From: PDCA [pdimberline@tiscali.co.uk]
Sent: 09 February 2018 07:42
To: 'Technical_Sewerage@yorkshirewater.co.uk'
Subject: 12 Westfield Street, Barnsley S70 6EZ Sewerage Consultation on R138776
Attachments: Westfield Street YW932.pdf; Westfield Street931.pdf; Westfield Street TOPO 2014 23 06-Layout1.pdf

12 Westfield Street, Barnsley, S70 6EZ - Sewerage H4 Consultation on R138776

Suggested surface water drainage

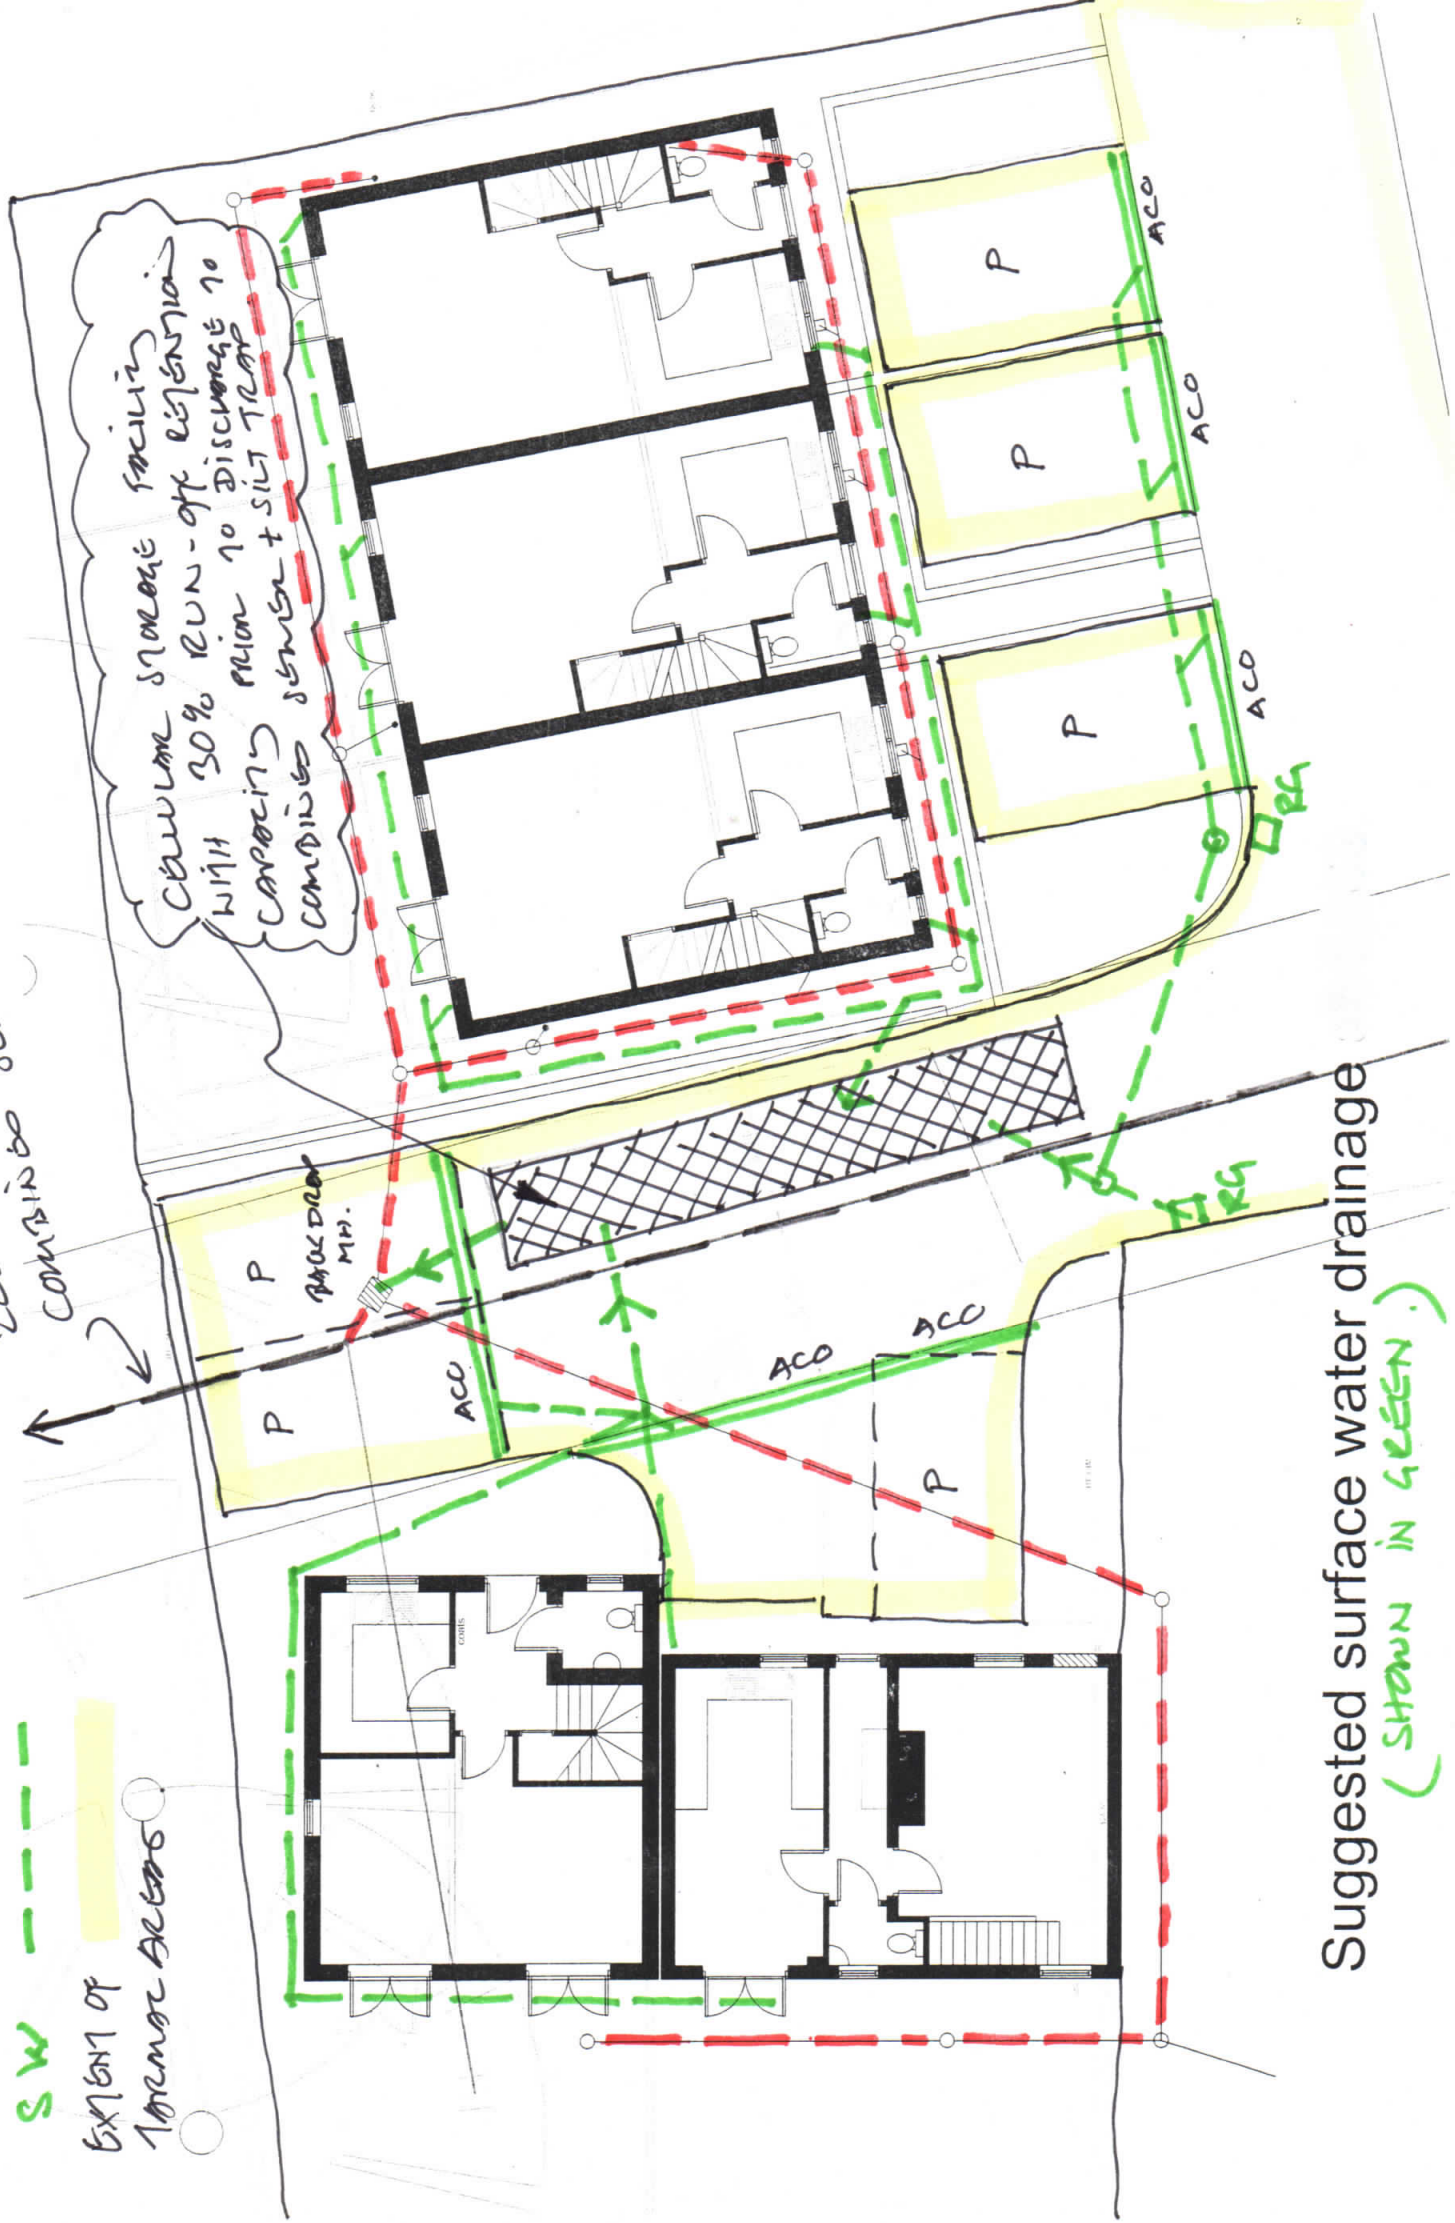
Thank you for your email. You'll have to demonstrate the site constraints on plan to discount soakaway. As a last resort yes sw can go to public sewer and the rate of discharge should be 70% of the proven existing. That reduced 1 in 1 rate should apply upto and including 1 in 100 plus climate change.
